SUBJECT: Duke Energy Carolinas, LLC (Duke Energy)  
Oconee Nuclear Station Units 1, 2, & 3, Docket Nos. 50-269, 50-270, 50-287  
McGuire Nuclear Station Units 1 & 2, Docket Nos. 50-369, 50-370  
Catawba Nuclear Station Units 1 & 2, Docket Nos. 50-413, 50-414  
Oconee Nuclear Station Independent Spent Fuel Storage Installation  
Docket No. 72-004  
Quality Assurance Program Topical Report Amendment 39

Pursuant to 10CFR50.54(a)(3) and 10CFR50.71(e), attached is Amendment 39 to the Duke Energy Carolinas Topical Report, Duke-1-A, Quality Assurance Program (hereafter referred to as Topical Report). Amendment 39 includes organizational changes, administrative, clarification and editorial changes, and a change approved by an NRC safety evaluation of another licensee.

**Change 1 Description:** The change added the following italicized material before the final sentence of the fourth paragraph of Section 17.3.3.2.3.1:

**Figure 17-2. Corporate and Offsite Organization**

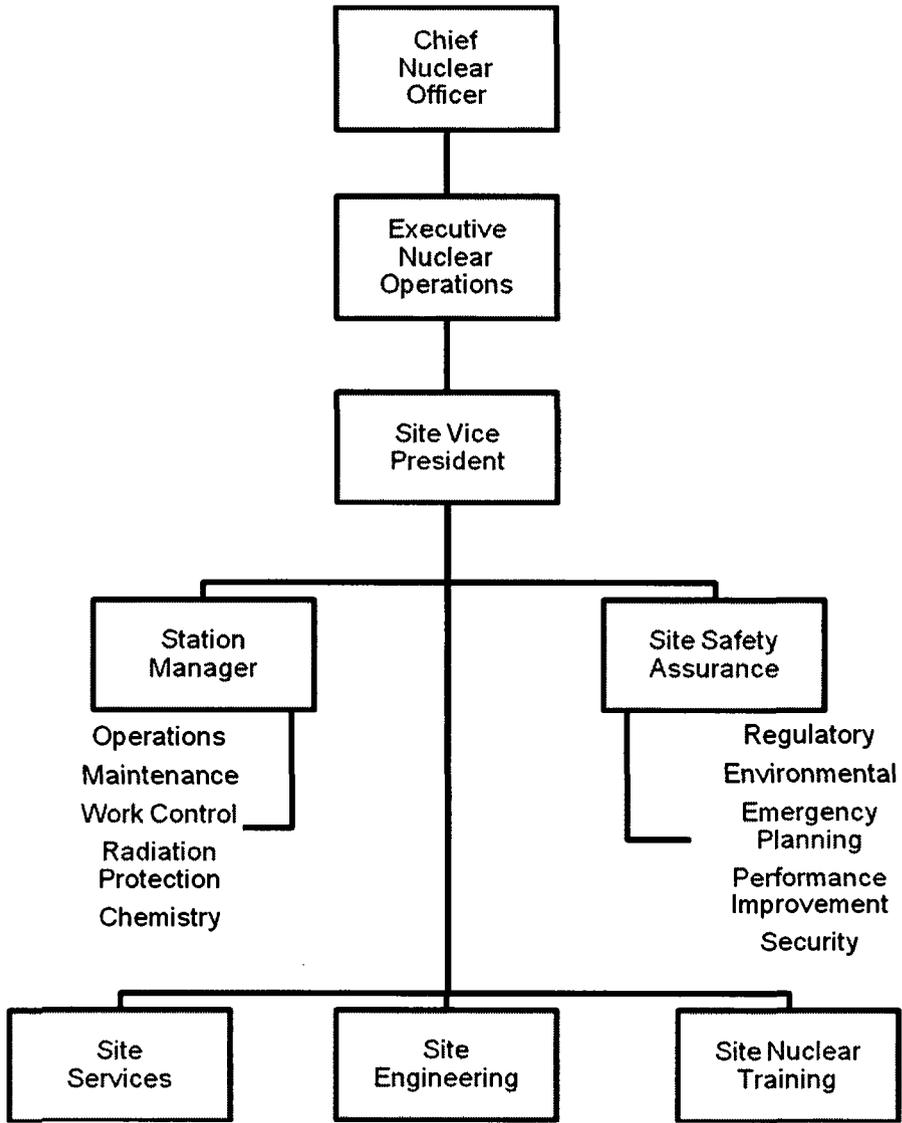
**Change 2 Description:** Changes to the Organization Description identified in Section 17.3.1.2 were made as follows:

1. This change consolidated the nuclear development non-QA Program related functions for overall new nuclear strategy with the Nuclear Plant Development organization pursuing a license for a new nuclear plant.

2. This change consolidated the Catawba, McGuire, and Oconee Nuclear Site organizations under a single executive for Nuclear Operations reporting to the CNO, instead of being split between the two Senior Vice Presidents in the prior organization. The executive for Nuclear Operations no longer has responsibilities for non-site organizations.

3. This change replaced the second SVP, Nuclear Operations (from the previous organization) with an executive for Nuclear Corporate reporting to the CNO. Reporting to this position are independent nuclear oversight, nuclear engineering, nuclear plant support, fleet centers of excellence, and the employee concerns program. This change consolidates the nuclear corporate functions under a single executive. This change reduces a level of management between the Chief Nuclear Officer (CNO) and the manager of independent nuclear oversight, who has unfettered access to the CNO, ensuring continued independence of that function. Consistent with 50.54(a)(3)(vi), this organizational change ensures that persons and organizations performing quality assurance functions will continue to have the

4. This change elevated the executive for Major Projects, to a position reporting directly to the CNO.
